ADDENDUM NO.1 TO PROJECT NO. 44313

**ELECTRICAL WORK
REPLACE ELECTRIC PANELS & RELATED WORK VARIOUS BUILDINGS
Mt. McGREGOR CORRECTIONAL FACILITY
1000 McGREGOR ROAD
WILTON, NY 12831**

April 26, 2013

4 PARTIAL SITE PLAN - BLDG. NO. 11 MESS HALL/VISITING/K-DORM
 E-302 SCALE: 1" = 30'

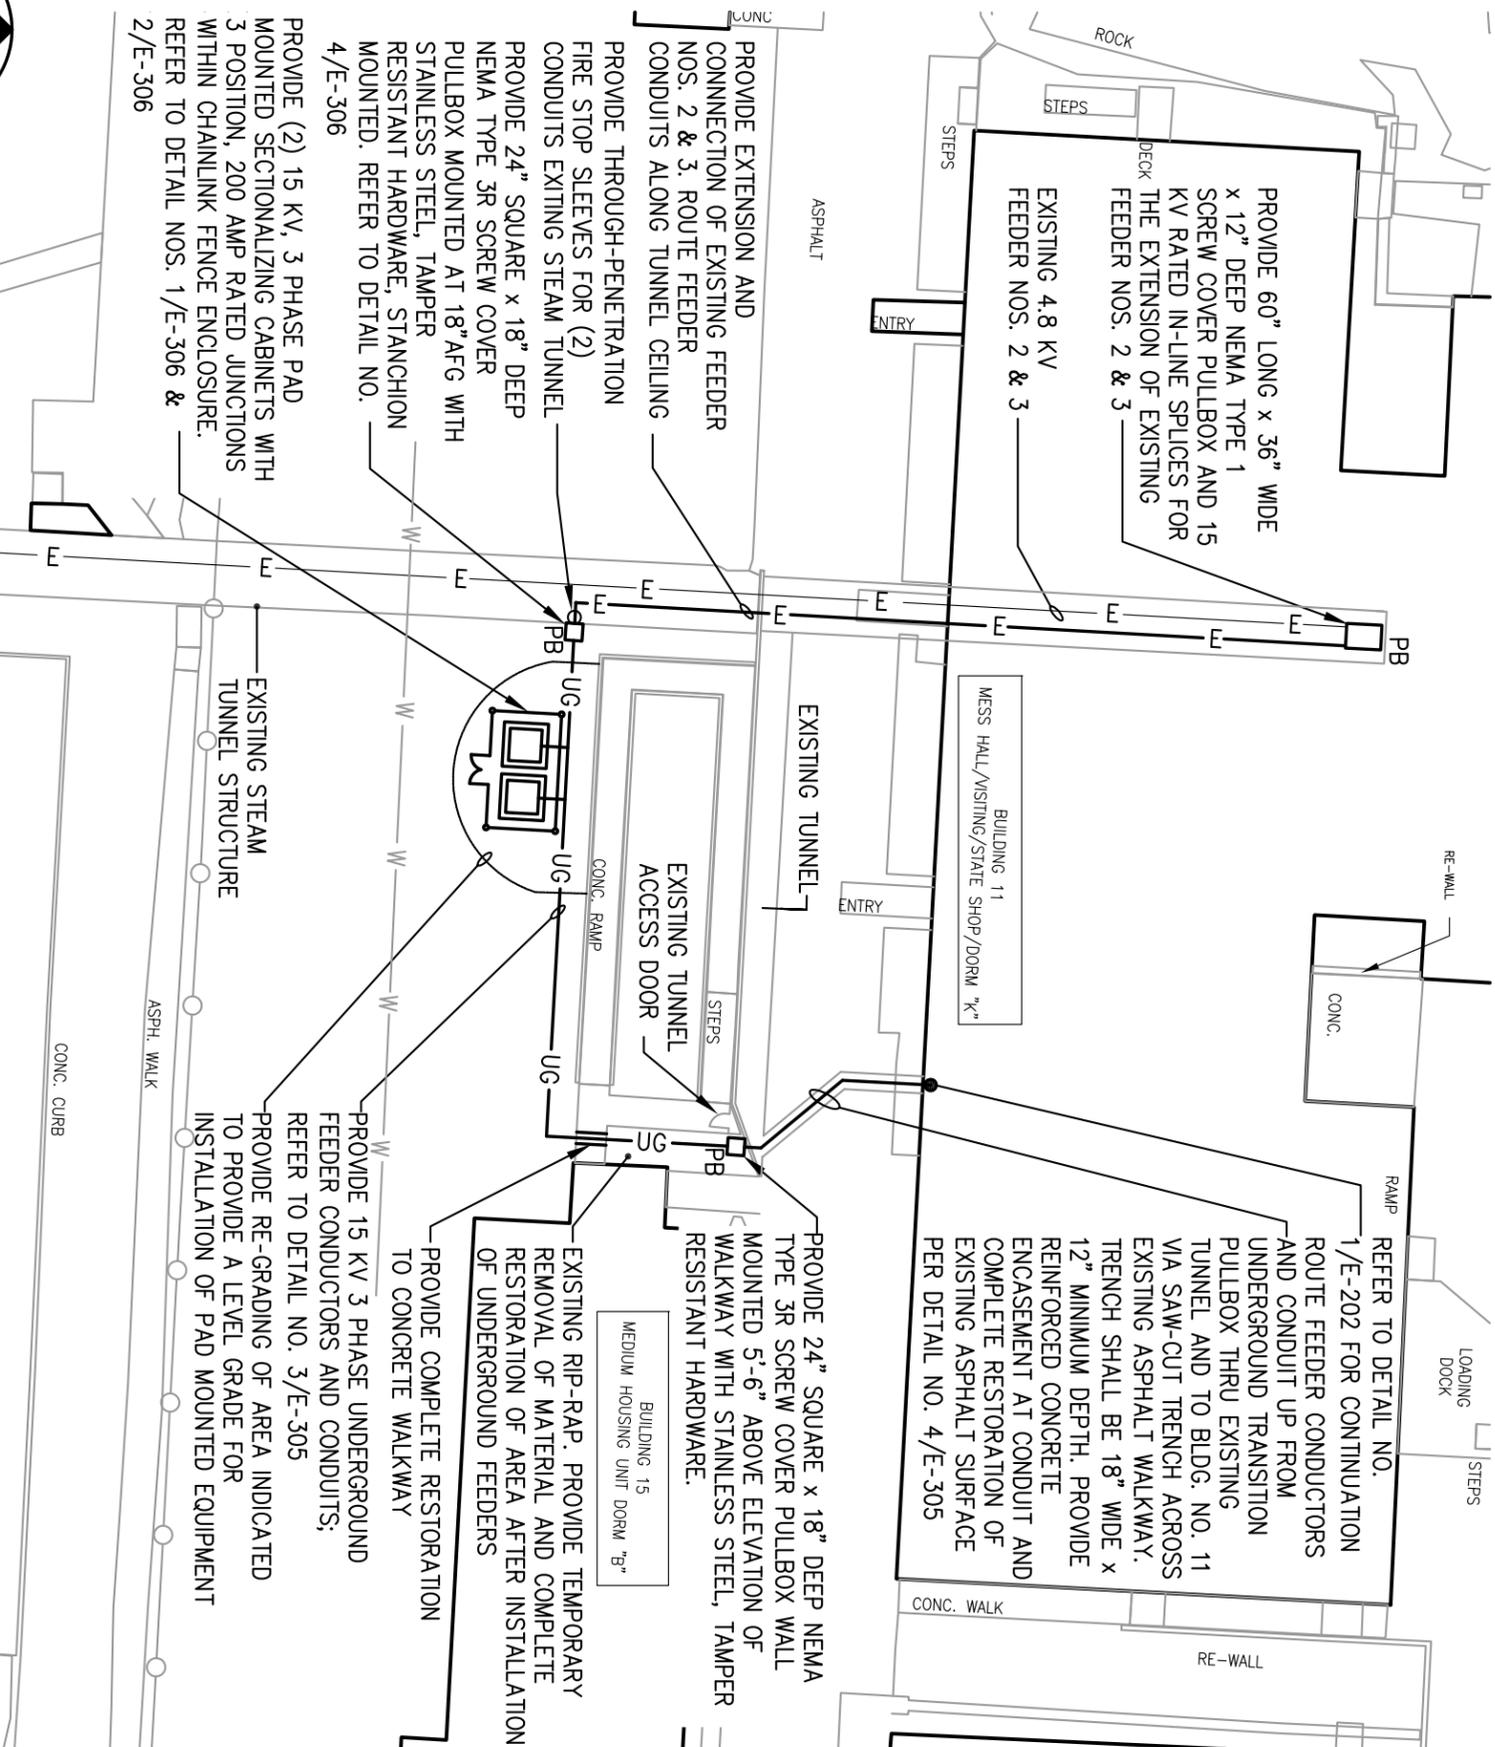
13. DRAWING NO. E-302 – PARTIAL SITE PLANS – Detail No. 4/E-302: Replace Detail No. 4/E-302 in its entirety as depicted on the contract drawings with attached Drawing No. SK-1 (11 x 17 inch sheet) This drawing accompanies this Addendum and forms part of the Contract Documents.

- NOTES:
 1. REFER TO BLDG. NO. 11 - POWER RISER DIAGRAM ON DWG. NO. E-301.
 2. PROVIDE THE REMOVAL AND DISPOSAL OF 350 CUBIC FEET OF ROCK. REFER TO SPECIFICATION SECTION NO. 312316.
